MEMORANDUM

SUBJECT: Public hearing and consideration of a Landmark Alteration Certificate to rehabilitate and add 1,030 sq. ft. to the main house linking it with the existing garage and construction of a new 530 sq. ft. free-standing, two-car garage, per section 9-11-18 of the Boulder Revised Code (HIS2013-00219).

1. Site: 3015 Kalmia Avenue
2. Designation: Individual Landmark
3. Zoning: Flex
4. Lot size: 7,576 sq. ft.
5. Applicant: Markel Homes/Kalmia Estates Dev., LLC.
6. Date of Construction: c. 1912
7. Historic Name(s): Lundgren-Harper House
8. Request: Rehabilitation of house and existing garage, additions, construction of 2-car garage.

Figure 8: Proposed Site Plan

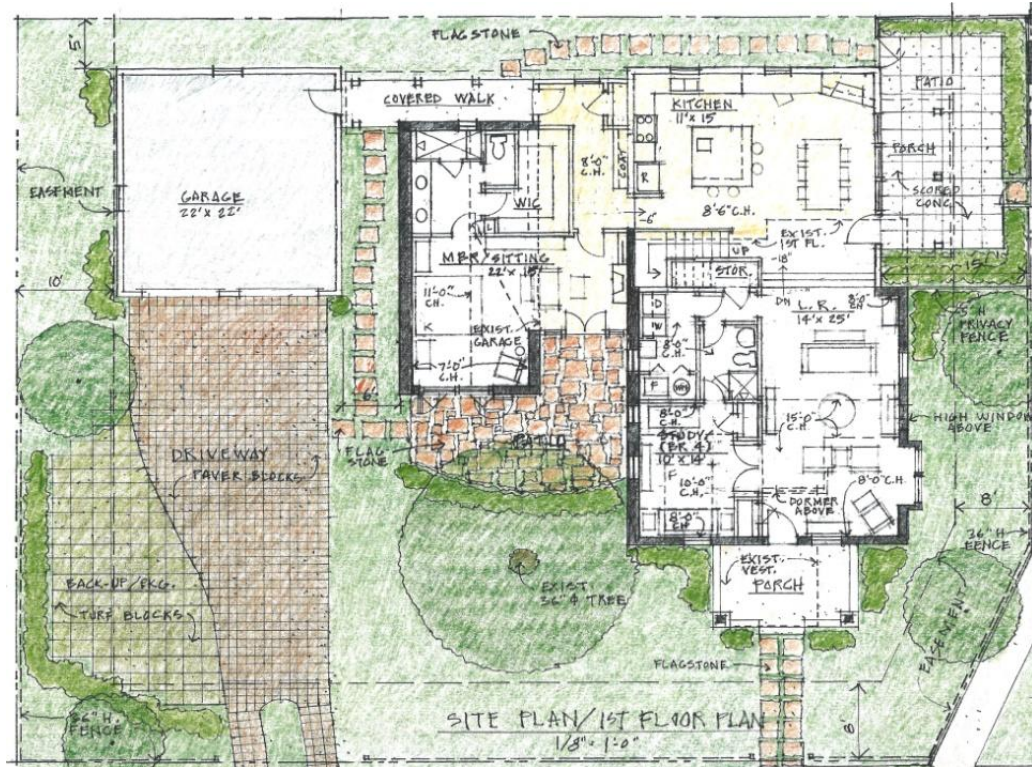
Drawings show the existing post-1947 north (rear) additions (comprising about 110 sq. ft.) to be removed and in their place the construction a two story addition to add approximately 1,120 sq. ft. to the remaining 1,250 sq. ft. house. This includes a 175 sq. ft. one-story addition connecting the west wall of the main house to the east wall of the historic garage. A 530 sq. ft., two-car garage is proposed to be linked to the west wall of the historic house by way of an open walkway running along the north wall of the garage. With the new garage, 1,670 sq. ft. of new construction is proposed for a total of 2,920 sq. ft. on the property (excluding the breezeway), where 1,750 sq. ft. of building now exist.

.3	<i>Respect the established orientation of the original building and typical alignments in the area.</i>	Addition does not affect historic orientation and alignments of building of the historic house, though connecting historic garage to the main house does change orientation. Attaching two historic buildings that were never attached likely problematic. Revise plan to maintain historic garage as detached. Resolve at Ldrc.	MAYBE
.4	<i>Preserve a backyard area between the house and the garage, maintaining the general proportion of built mass to open space found within the area. See Guideline 2.1.1.</i>	No usable garden between, however, 8' distance between house and garage will be filled by proposed connector. Maintain house and garage as detached.	NO

However, staff finds that the mass and scale of the proposed rear addition will overwhelm the historic character of this diminutive house and garage. Likewise, connecting the historic house and garage will have an adverse affect on the historic integrity and character of the property, especially that of the garage.

To this end, staff recommends that the applicant significantly reduce the mass and scale of the additions as outlined in the design guideline analysis and redesign the proposal so that the existing house and garage remain detached. In doing this, the overall amount of built area will be reduced so that the open, rural character of the property will be better maintained. Staff considers that to

- (A) Revisions to significantly reduce the actual and perceived mass and scale of the proposed rear addition to the main house;
 - (B) Dormers and fenestration that have been revised to be more compatible with that of the historic house;

- (C) The continued detachment of the historic house and historic garage; and
 - (D) The significant reduction of the overall amount of built area on the property to preserve the historically rural character of the property.

Figure 12: Existing North Elevation (rear)

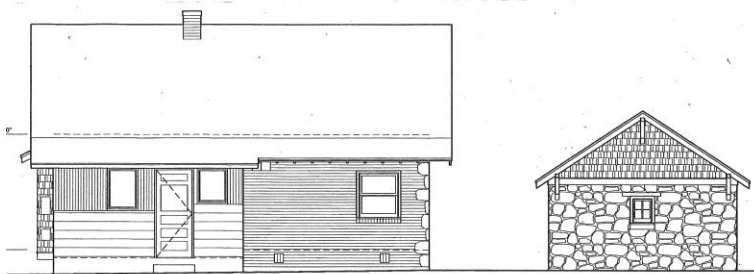
Plans show the north (rear) elevation of the addition to feature a gable end roof at the height of the existing house with two, full height shed dormers at the east and west sides of the roof. The existing rear stone and brick portions of the north elevation (post-1947 additions) are shown to be completely removed. This face of the house is shown to be simply fenestrated with two-over two, double-hung windows on the first floor and a small four light casement window on the wood-shingled gable. The proposed new garage is shown to have one double-hung window on the north face and to be stuccoed with the same material as the addition to the main house.

though will create a strong cross gable roof form that at 36' in length will exceed the 26' width of the east wall by 10'. Consider reducing mass of addition and roof and lowering roof below that of height of existing house. Reduce height and width of shed dormer to further reduce mass of addition when viewed from the east. Resolve at Ldrc.

Figure 16: Existing west Elevation

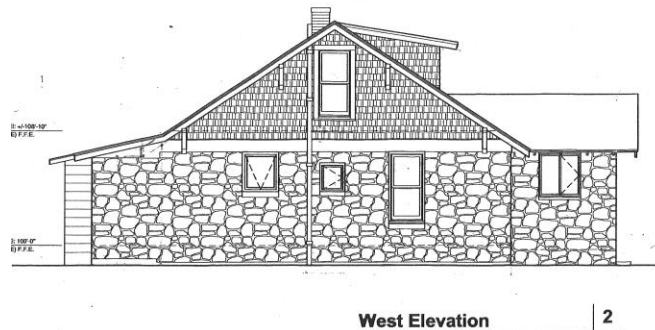
On the west face of the proposed addition a 31' long, full height dormer is proposed with three one-over-one, double hung sash windows. The west face of the proposed garage is shown to feature a single, one-over-one, double-hung window.

3.5	Dormers		
	<i>Dormers are traditional roof elements that either extend the space under the main roof or serve as decorative elements to the main roof. They generally follow the pitch and form of the main roof and are always secondary to the main roof massing. The introduction of dormers may dramatically change the building's appearance, and therefore may not be appropriate in all circumstances.</i>		
	Guideline	Analysis	Meets Guideline?
.4	<i>The size, scale, and style of new dormers should be compatible with existing dormers on the structure. The form of roof dormers should be compatible with the main roof form.</i>	At 19' (east) and 29' (west) in width, proposed dormers are not in scale with the house. Reduce size of proposed dormers to be more compatible with 12' wide dormer on historic house. Consider lowering dormers below ridge and/or wall height to be more in keeping with scale of dormer on main house. Resolve at Ldrc.	NO
